**WYONG HOSPITAL EXPANSION, 664 PACIFIC HIGHWAY, HAMLYN TERRACE -SSD 9536**

Thank you for the opportunity to review and provide comment on the Environmental Assessment for the Wyong Hospital Expansion. Council has reviewed the information in the Environmental Impact Statement in response to your request and provides the following comments for your consideration.

Figure 4.9: Relationships between bullet vehicle impact speed and probability of a MAIS 3+ injury to a target vehicle occupant for different crash configurations

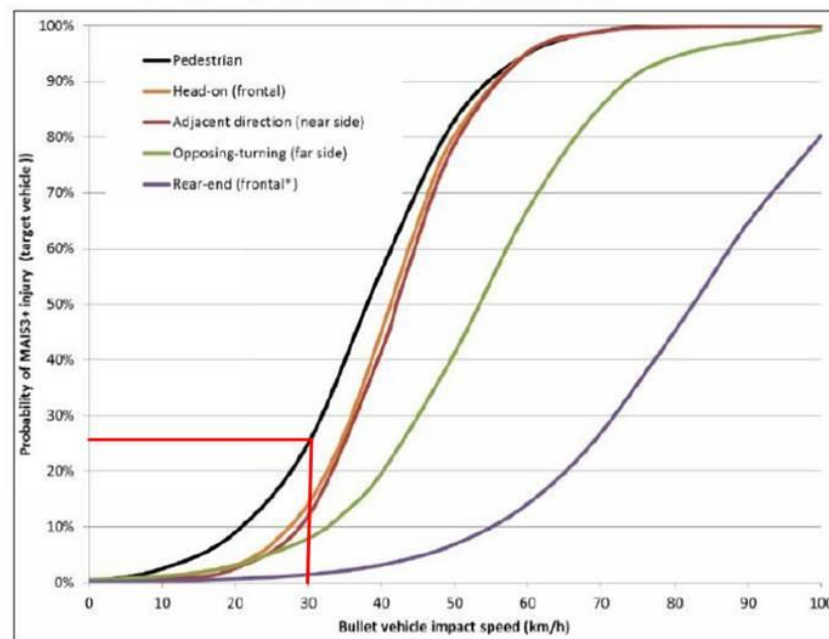
6. With the increased car parking, upgraded Emergency Department, increased ambulance accesses, delivery and loading provisions etc. a review of the safety of road and road related areas of the complex, not only external to the development and not only during the construction phase, but for the long term operation of the facility is warranted.
7. The site is a mix of traffic environments & road users, consisting of visitors, staff, delivers, emergency vehicles, pedestrians etc. Although it is recognised that fundamentally the site will hopefully be a low speed environment, you do not need a high-speed environment to cause serious injury. The figure below, contained in a number of Austroads guides, is based on actual crash occurrences and demonstrates that a vehicle /pedestrian conflict at 30km/h has a greater probability of 1 in 4 of resulting in a serious injury or fatality.
